UNITED STATES PATENT AND TRADEMARK OFFICE

APPLICATION NO.	FILING DATE	FIRST NAMED INVENTOR	ATTORNEY DOCKET NO.	CONFIRMATION NO.
09/531,531	03/21/2000	Yuichi Shirota	257718	7092

Office Action Summary

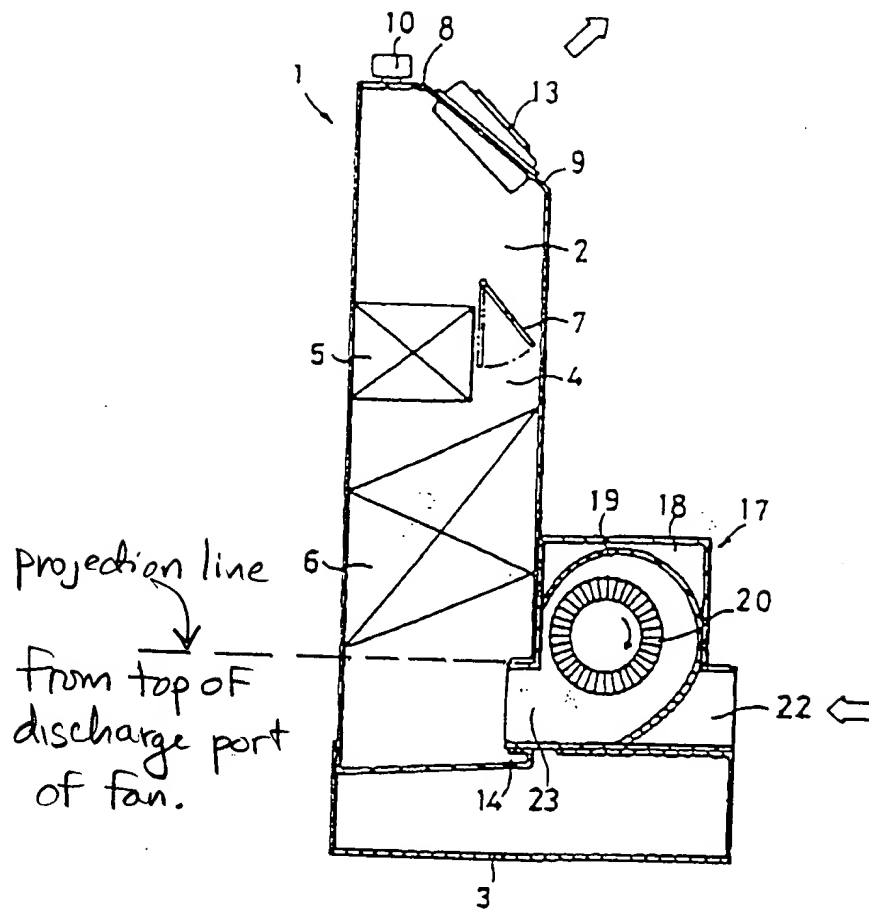
In claim 6, line 7, applicant has added the additional limitation "disposed in said case to have a lower space in said case under a bottom surface of said cooling heat exchanger to be slightly inclined..". It is not clear to the Examiner whether applicant is trying to claim that: 1) the bottom surface of the cooling heat exchanger is "slightly inclined" or 2) whether the "space" between the bottom surface of the cooling heat exchanger and the case is inclined or 3) whether the bottom of the case is inclined. If it is possibility 2) that applicant is attempting to claim, the Examiner does not believe that a "space" lacking any structure of its own (by definition it is a

void) is properly claimed to have an "orientation". Generally structural components (e.g. an evaporator or casing portion) have an orientation, not a "space". Please clarify the claim so that the reader is sure what structure is being claimed as inclined.

第5図

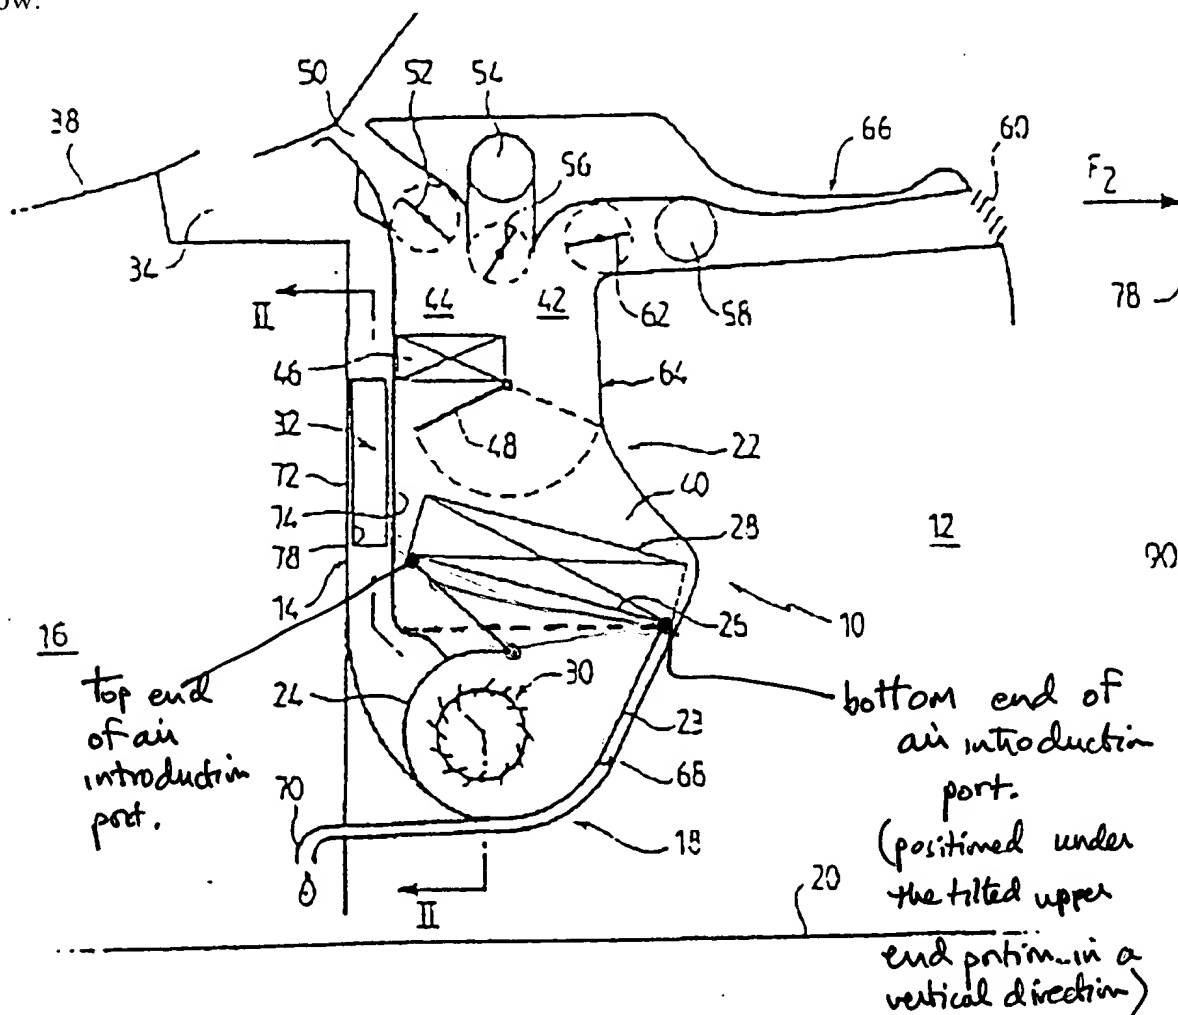
JA '365 (Fig. 5) shows the essential subject matter of claim 6 with the exception of the details of the fins on the evaporator (the evaporator is shown schematically). Arguably, elements 13 may not be "mode members" as called forth in the claims, but the translation submitted is so abbreviated these elements are not even mentioned. In applicant's response (paragraph bridging pages 13-14) translations are discussed but have not been provided. Please provide them in response to this action. As well, the top of the fan discharge (23) appears to be slightly below the bottom of the lowest point an evaporator (6) when a horizontal line is drawn across the reference as shown below:

JA '049 also shows the essential subject matter of claim 6 however it too lacks a showing of fins on the evaporator 28 but does show mode control doors 52, 56 and 62. It appears to show the top end and bottom end of the air introduction port to be positioned as claimed. See the illustration below:

To have replaced elements 13 of JA '365 with the mode control doors of JA '049 to distribute air to vent, foot and defrost outlets to improve occupant comfort would have been obvious to one of ordinary skill. Alternatively, to have off-set blower 30 of JA '049 to one side of the evaporator 28 in the manner taught by Figure 5 of JA '365 to permit a reduction in height of the unit for mounting in smaller vehicle spaces would have been obvious to one of ordinary skill.
